Appendix D – RC216016 Decision and Approved Plans

Section 133A Resource Management Act 1991

Report pursuant to section 42A of the Resource Management Act 1991 recommending that minor mistakes or defects in a resource consent decision be corrected.

Resource Consent Number: RC216016

Project No	FSIL-0085
Dwg #	S102
Sheet	1
Revision	4

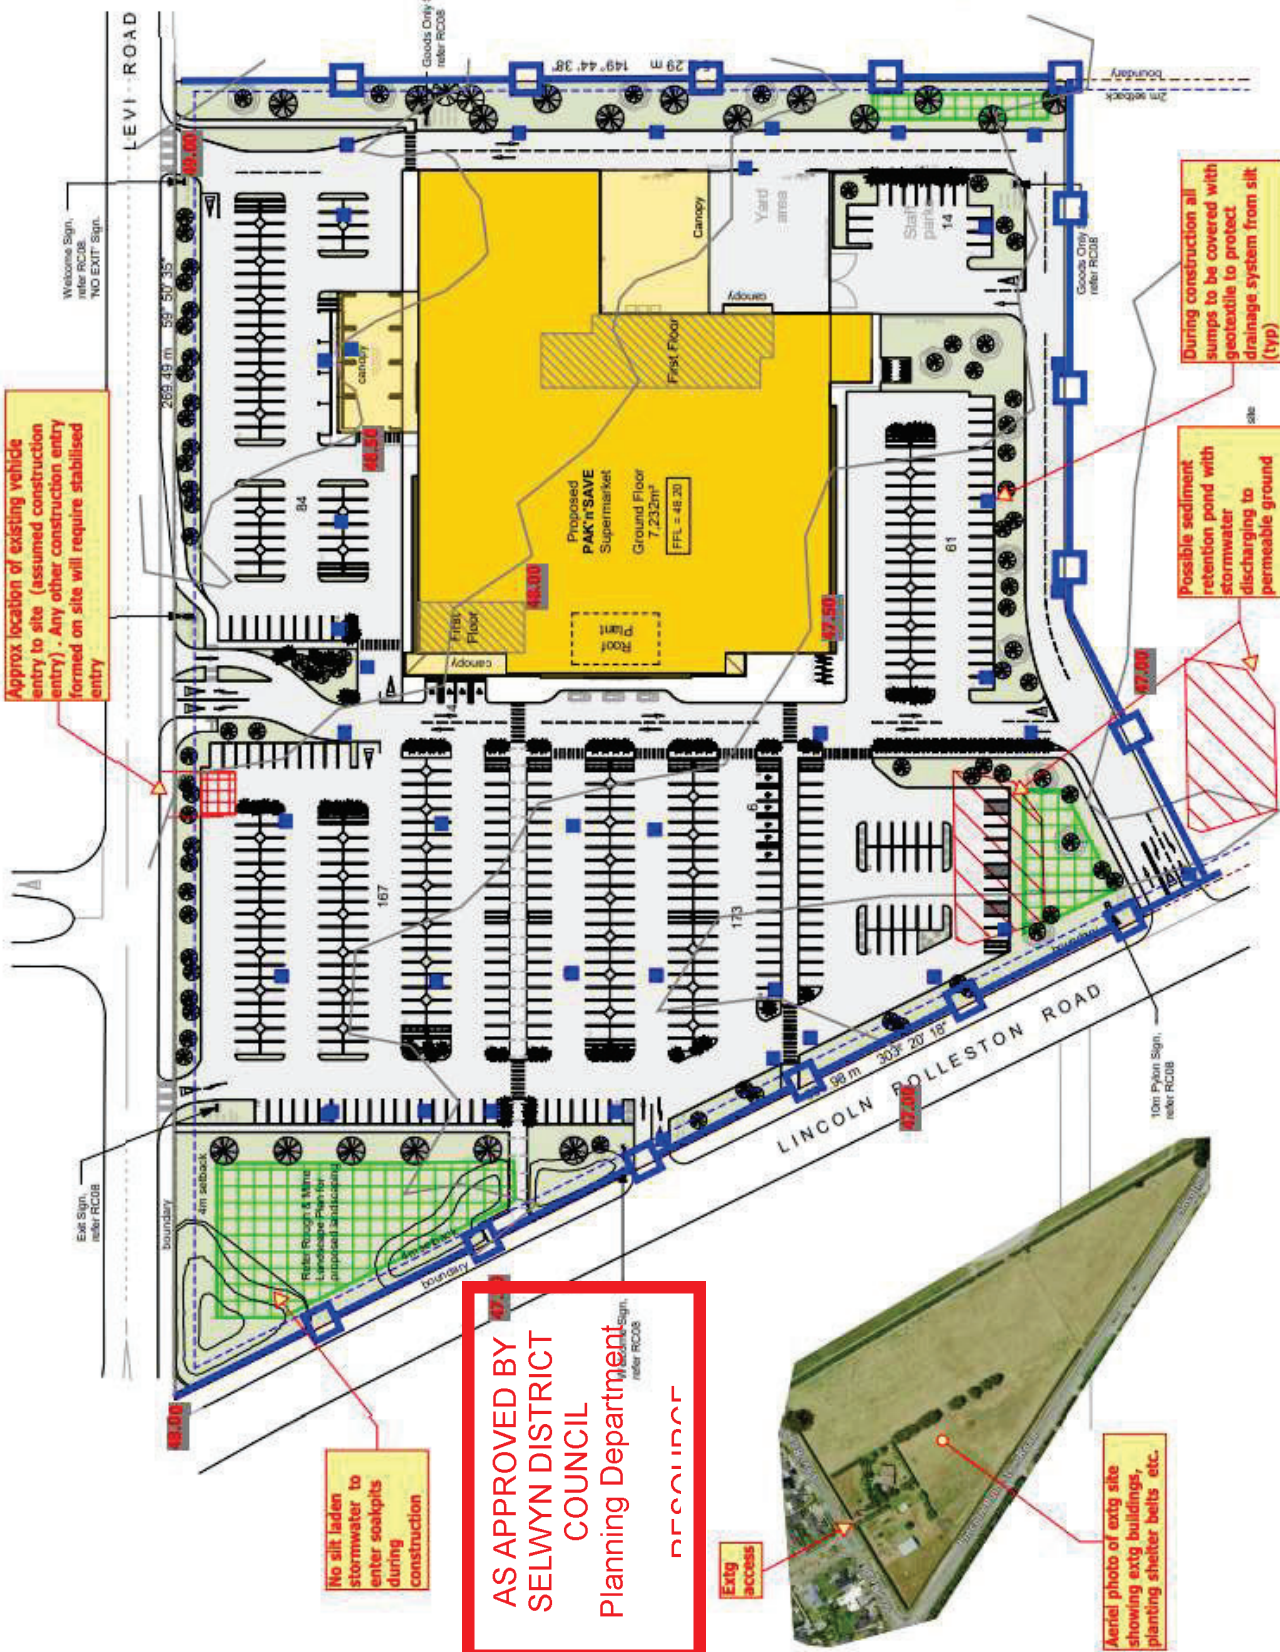
7. Condition 1(v) references an earlier plan provided by Abley dated 19 August 2022. As part of additional work undertaken relating to the Levi Road / Lincoln Rolleston Road, Abley updated these plans on 23 August 2022. The revised plan reflects the final discussions held between the applicant and the Council and the Commissioner’s decision. The date on the Abley plan was 19 August 2022, this needs to be updated to 23 August 2022 in the decision document. The relevant plan is also to be replaced and entered into the Council records.

- (v) *Levi Road and Lincoln Rolleston Road Frontage – Roundabout Scheme Indicative Concept Design (Abley, Project No. FSIL-J085, Drawing No. S102, 23 August 2022).*

- (x) Levi Road and Lincoln Rolleston Road Frontage – Roundabout Scheme Indicative Concept Design (Abley, Project No. FSIL-J085, Drawing No. S102, 23 August 2022).
